EMAIL TRANSMISSION

ORGANISATION: Department of Planning and Environment DATE: 9 November 2017

SUBJECT: Broken Hill North Mine – Consolidated Response to Agency Submissions

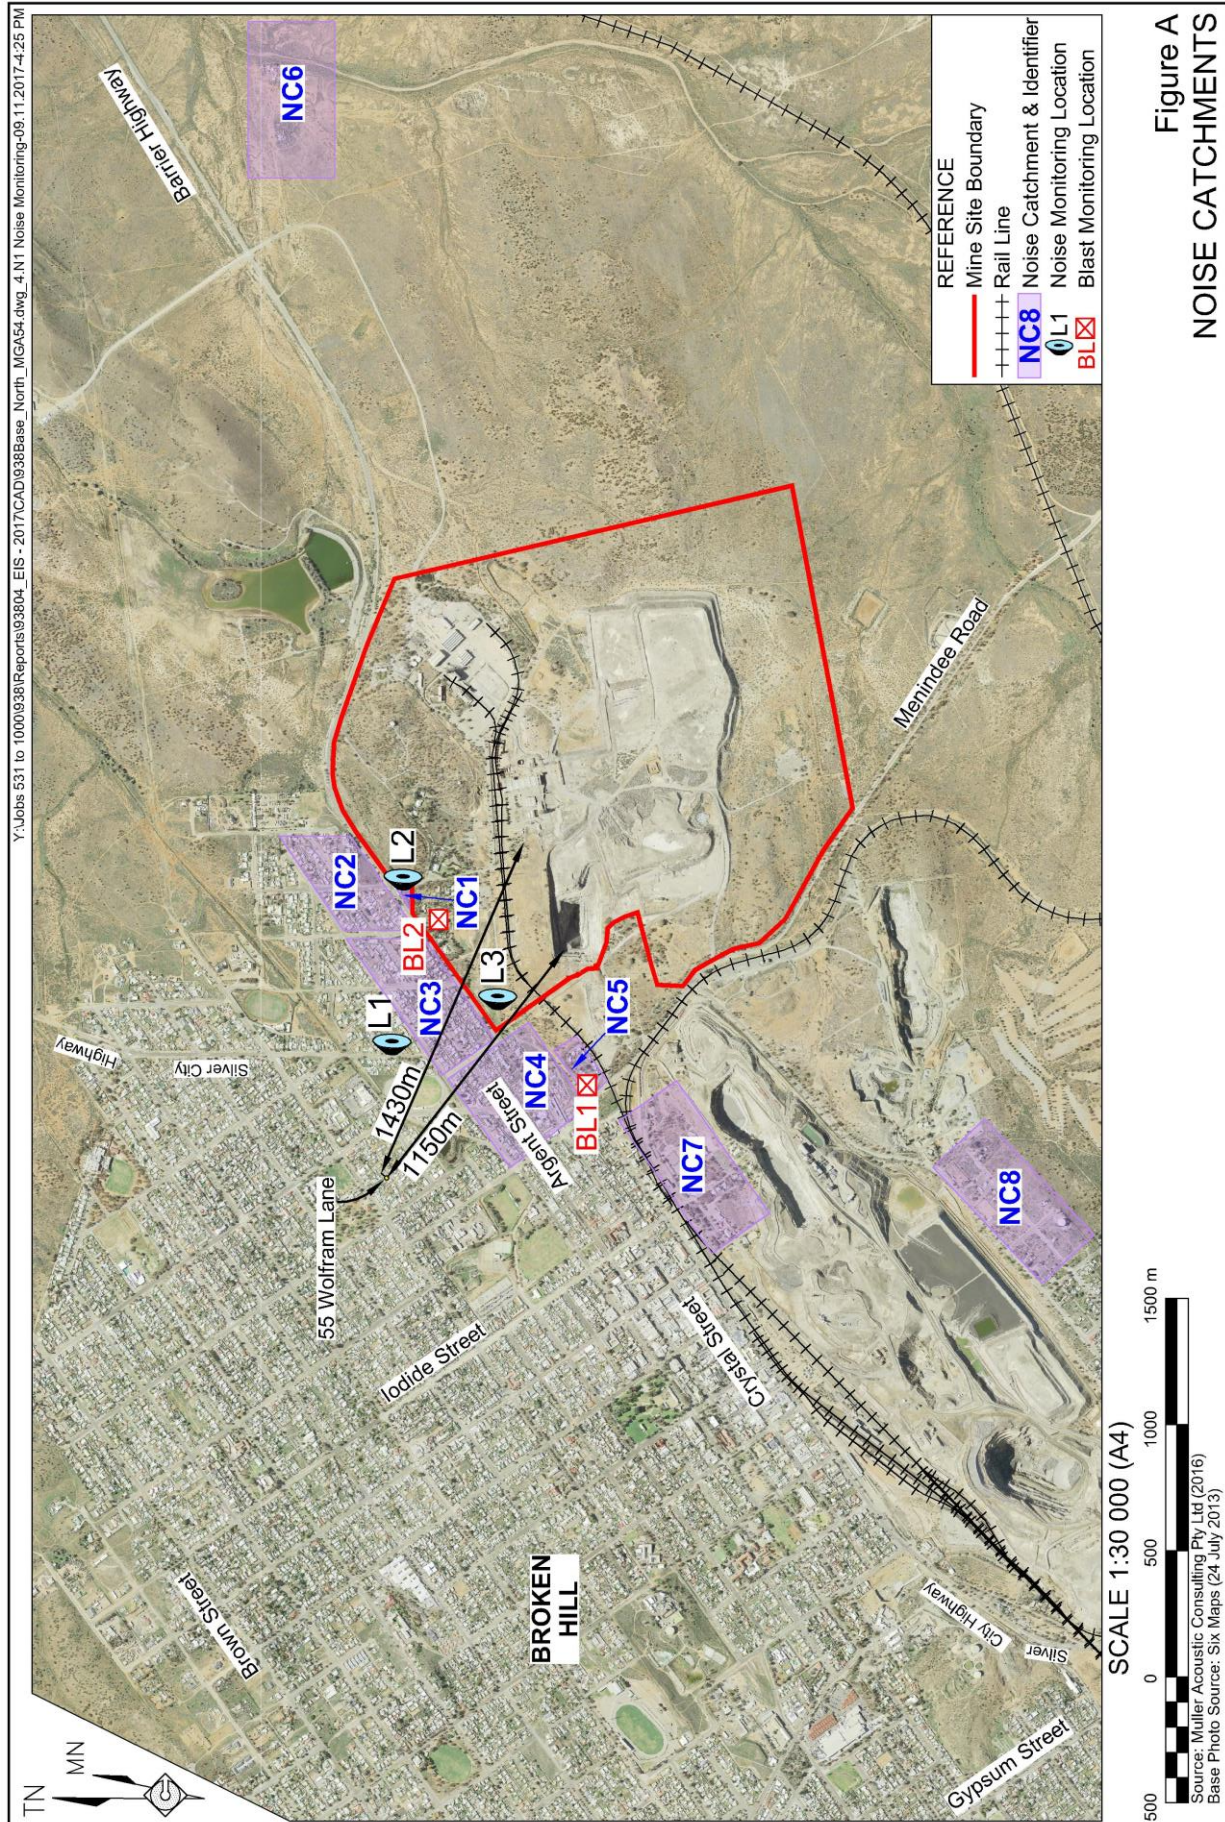
Works associated with the bulk sample have resulted in noise complaints from multiple complainants. ... The Department and the EPA are concerned that noise may be an issue for the recommencement project - especially as the magnitude of works would increase significantly.

I note that the recommencement project includes a 4m high amenity bund and a relocated haul road. However, the EPA and complainants believe that the noise is coming from the mine portal. If that is the case, it seems that the noise bund would not offer much/if any noise mitigation.

Please detail the difference between the existing bulk sample operations and the proposed recommencement project, specifically with relation to noise emissions.

Perilya Broken Hill Limited (the Applicant) has been made aware of an issue with noise associated with the current exploration activities raised by two neighbouring residents living in the vicinity of 566 Wolfram Lane. **Figure A** presents the location of the relevant residences. Upon being advised of the issue, the Applicant immediately ceased above-ground trucking operations between 10:00pm and 6:00am. The Applicant also consulted with the residents, however, consultation broke down after the residents used social media to publish

In relation to the differences between the existing exploration and the proposed activities, the Applicant notes the following.

- The Proposal would include construction of an approximately 4m high amenity bund adjacent to the section of the haul road in direct line of sight to surrounding residents. All other sections of the haul road would be located either within the Cosmopolitan Open Cut or would be shielded by existing topography.

Finally, in relation to your comment that the noise emissions may be sourced from the portal, the Applicant notes that the portal is located approximately 35m below surface, adjacent to the highwall of the Cosmopolitan Open Cut which would provide the maximum noise protection for residences located to the northwest of the Mine Site. Indeed, at a distance of approximately 1,100m from the portal and 1,500m from the section of the haul road adjacent to the proposed amenity bund, the Applicant is confident that noise emissions associated with the Proposal would not exceed the relevant criterion at the identified residence.

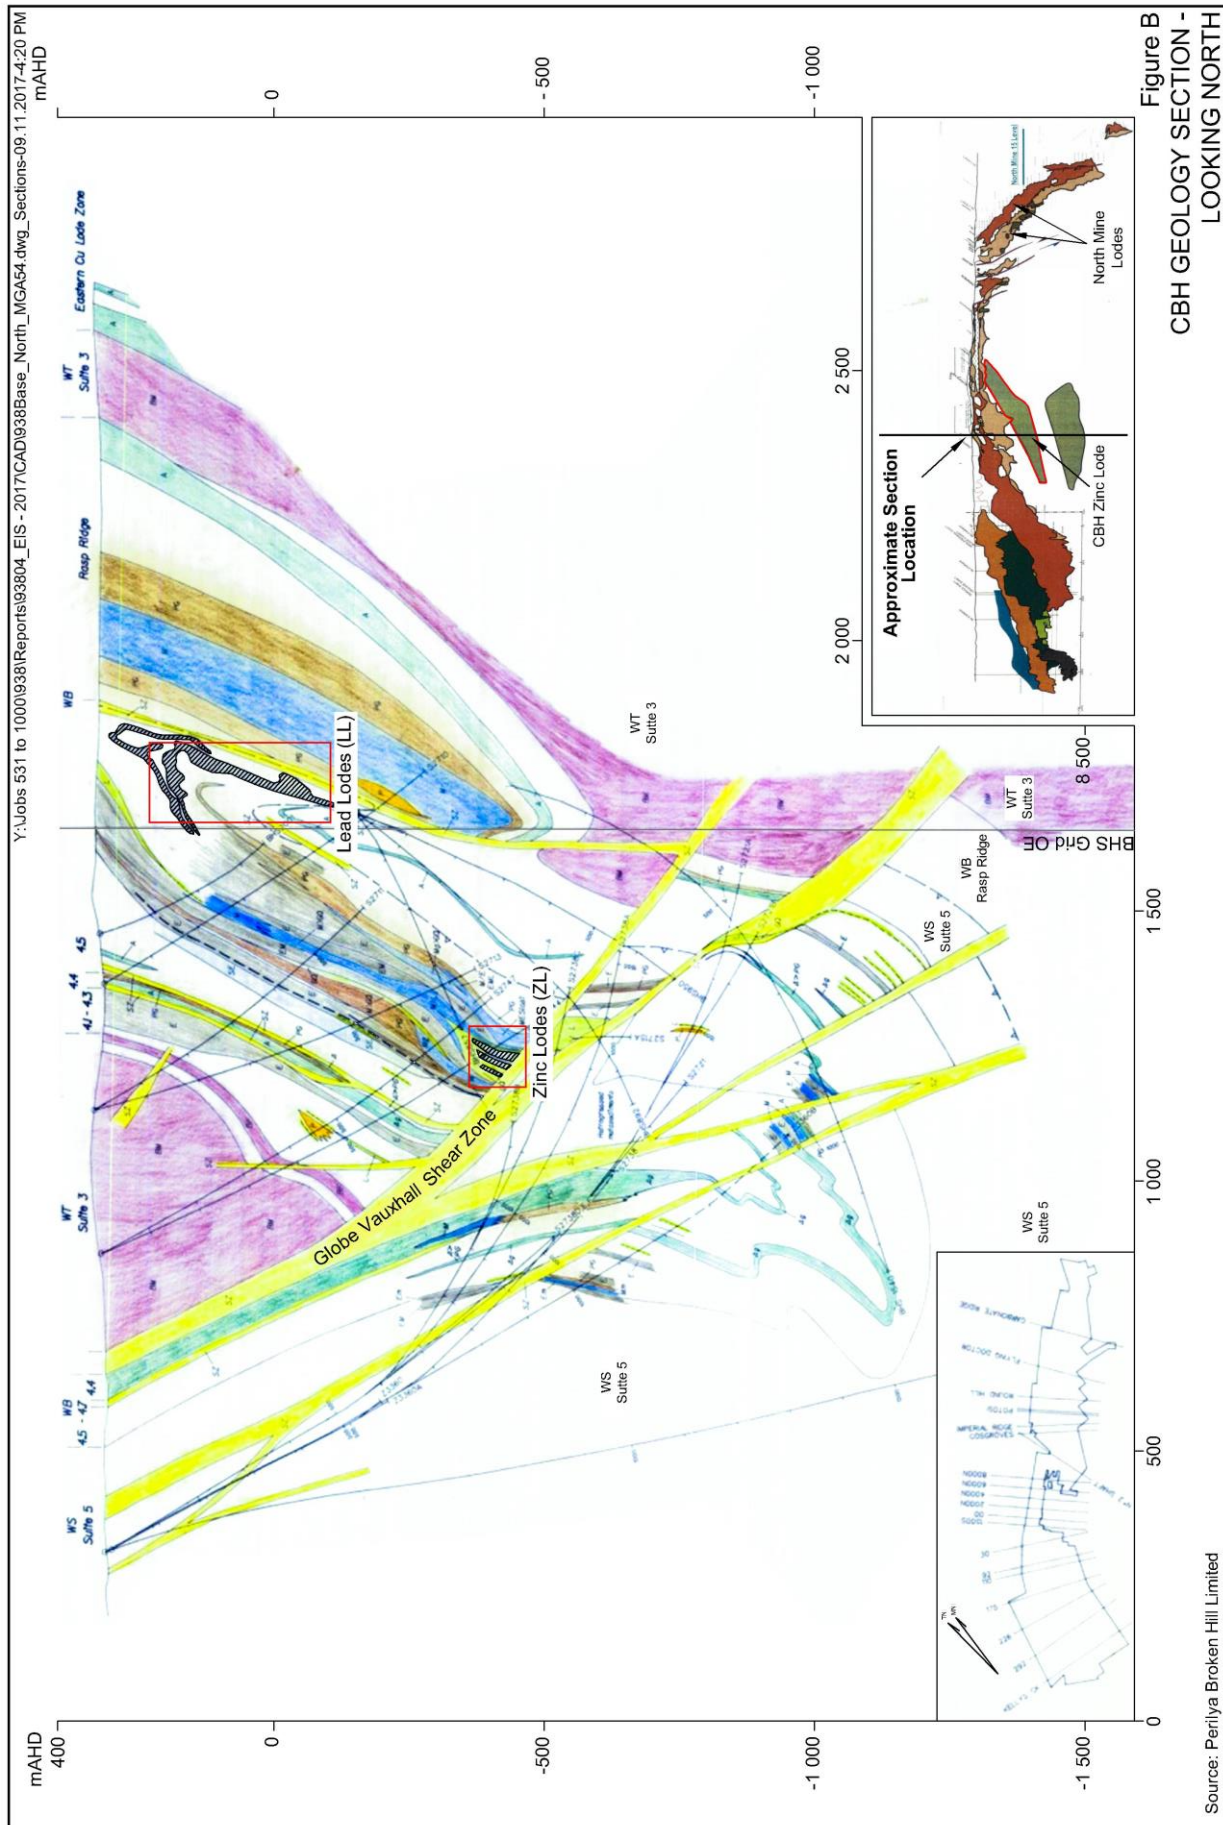
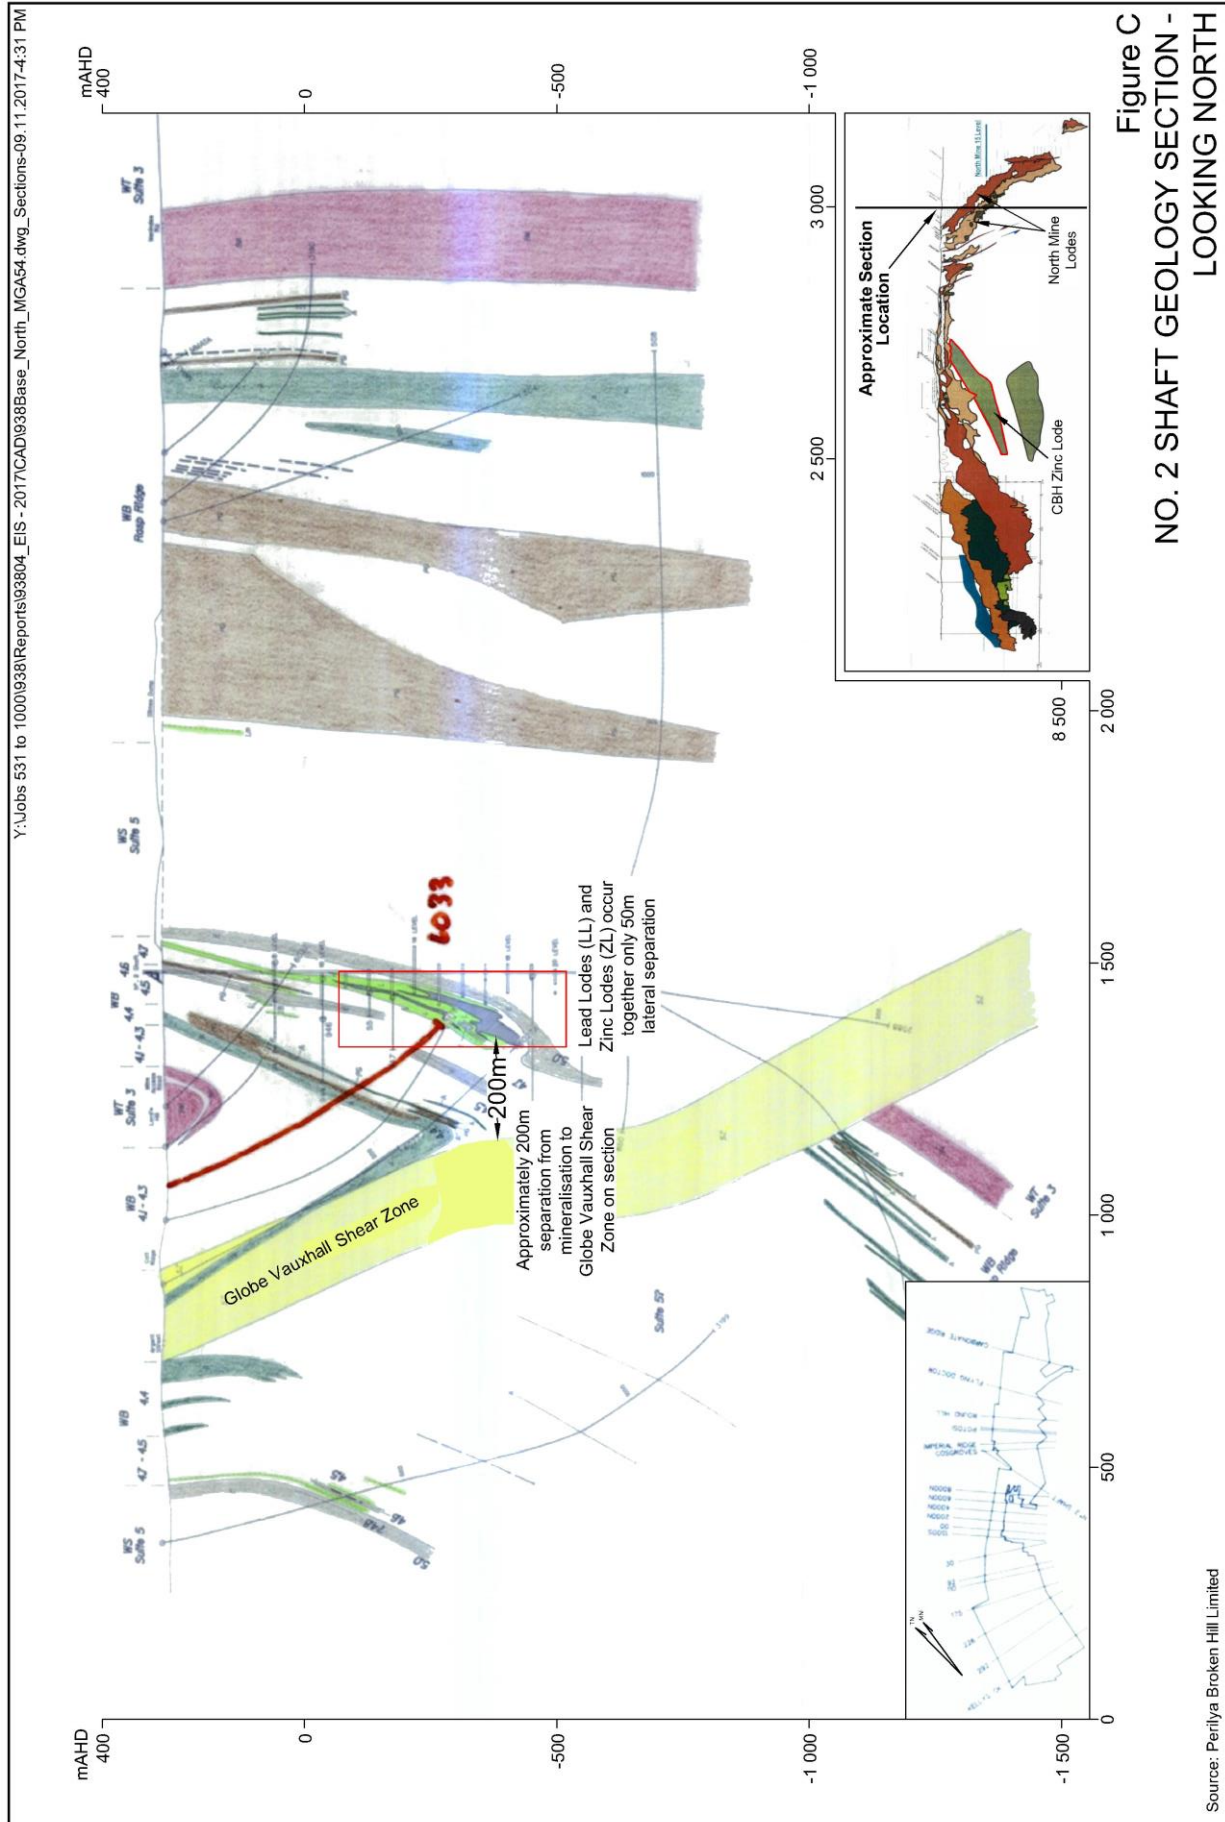
The 3mm/s criteria only applies to the Rasp Mine zinc lodes.

In support of Perilya's request for 5mm/s blasting criteria at North Mine, please provide information about the geological setting of the North Mine.

The Applicant advises that the Zinc Lodes mined at the Rasp Mine occur in a different stratigraphic and structural setting to the Zinc Lodes within the North Mine (**Figures B and C**). In particular, Rasp Mine Zinc Lodes occur immediately adjacent to and above the Globe Vauxhall Shear Zone. That shear zone within the Rasp Mine dips to the southeast, and is exposed at surface in the vicinity of Argent Street in Broken Hill. The Applicant understands that the Shear Zone in the vicinity of the Rasp Mine acts to exacerbate impacts of blasting undertaken in close proximity to the zone.

By contrast, the Zinc Lodes within the North Mine Site are located at least 200m from the Globe Vauxhall Shear Zone and similar transmission of blast vibrations is not anticipated. Notwithstanding this, the Applicant has committed to implementing a program of management and mitigation measures in Section 3.5.5 of the Response to Submissions that would ensure that potential adverse blast-related impacts are detected before they become a compliance issue, enabling the Applicant to adjust its practices to ensure compliance with the standard blast criteria.
